I have the honour to inform you that the original design and estimate of the Museum provides for kapchas & lime plaster to the wall above the circular lintel carrying the dome.

Museum Building

REFERENCE No E 161 of 1925.

PLAN OF MUSEUM

— SECTION ON A-B —

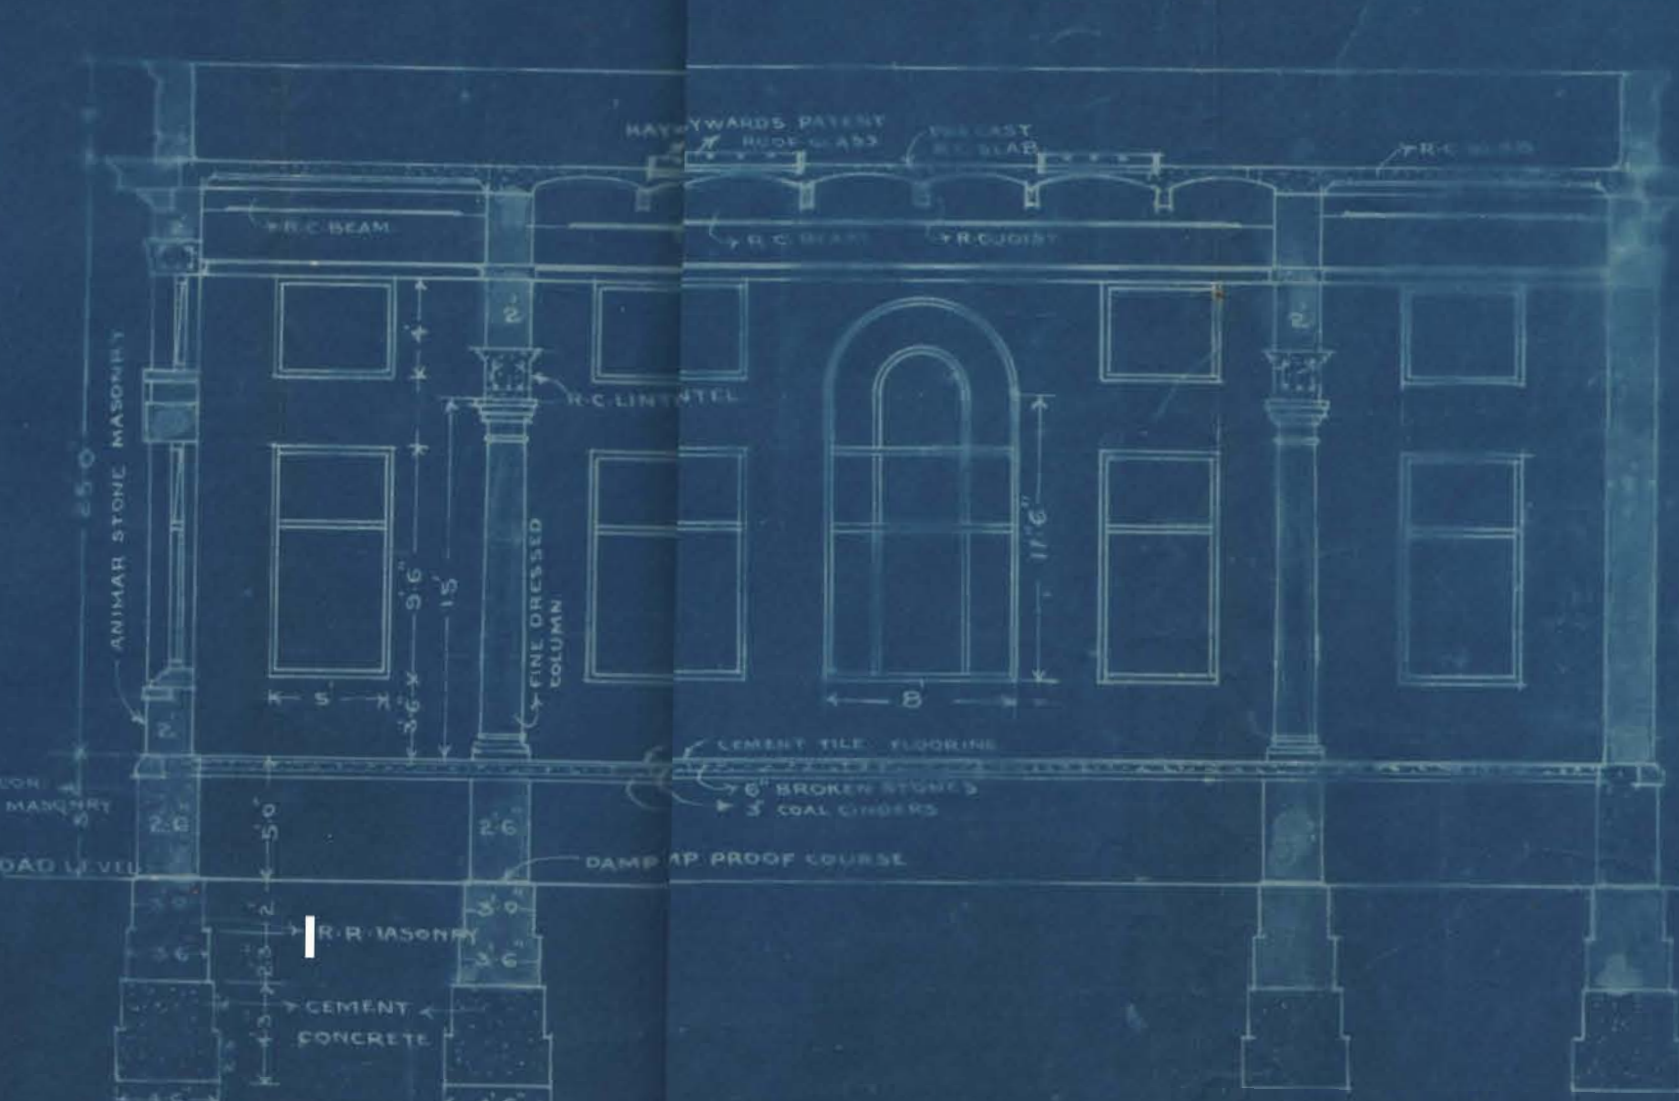
I have the honour to inform you that the original design and estimate of the Museum provides for kapchas & lime plaster to the wall above the circular lintel carrying the dome.

In a monumental building like the museum, kapcha work at a place like this will appear incongruous. I therefore propose to change this item into dressed stone on both the sides with circles in relief as shown in the accompanying blue print marked A.

For similar reasons I also propose to change Animar dressed on one side & plaster inside to fine dressed masonry dressed on both the sides from roof to main cornice of dome base.

The proposed changes will entail an excess expenditure of Rs.1037 as per estimate attached herewith.
